GFA AIRWORTHINESS DIRECTIVE

SUBJECT: Inspection of Exhaust Muffler Part No. 979402 fitted to Rotax 914 series engines.

**TECHNISCHE INFORMATION NR.
SERVICE INFORMATION NO.
SI36-026
SI22-008
SI40V1-009**

INSPECTION OF THE EXHAUST MUFFLER PART NO. 979402 FOR ROTAX® ENGINE TYPE 914 SERIES ASB-914-028R1

see fig. 1

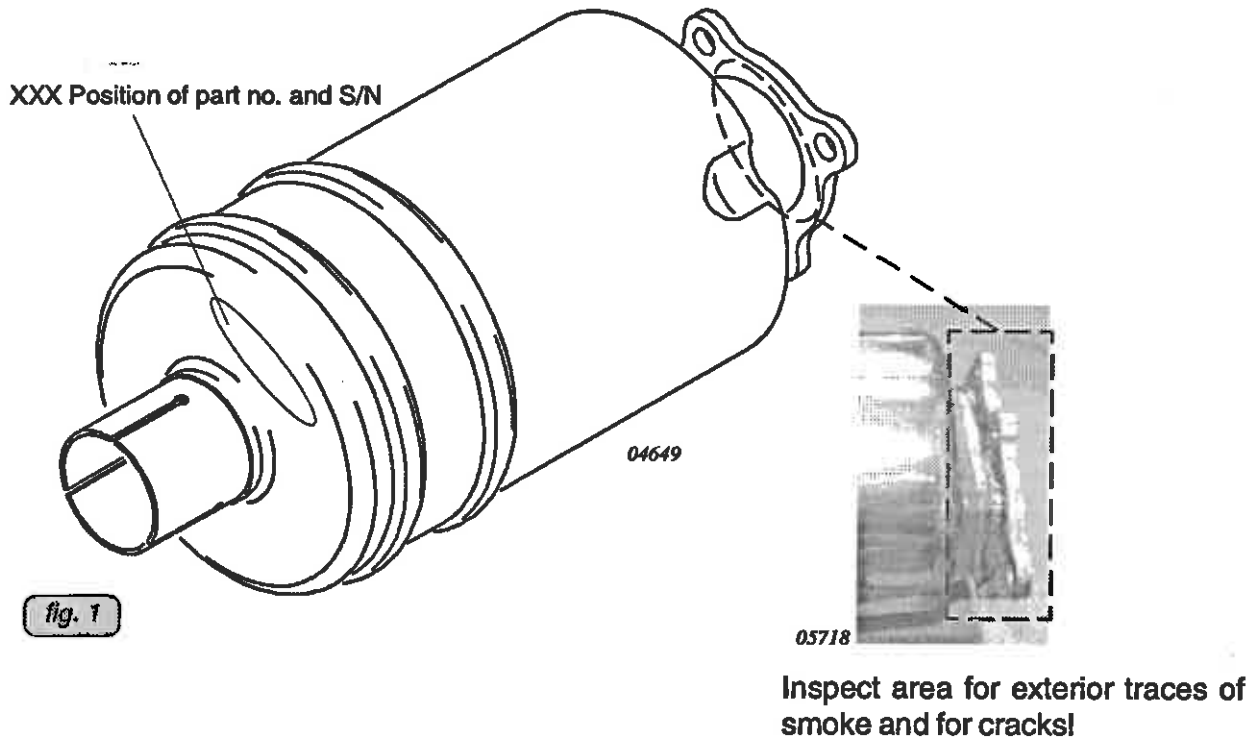
- Visually inspect exhaust system (without turbocharger) in accordance with the MM 914F section 13.5.2.
- Visually inspect of the exhaust muffler for exterior traces of smoke or existing cracks.

◆ **NOTE:** Particular inspection in the area (exhaust flange) for exterior traces of smoke or existing cracks in the fillet (weld inlying) (as shown in fig. 1).

- If exterior traces of smoke or cracks are detected, do not operate the aircraft and immediately contact the nearest ROTAX_® Authorized Distributor or their Service Centers for further action. (see also our official ROTAX-Web-Site: www.rotax-aircraft-engines.com).
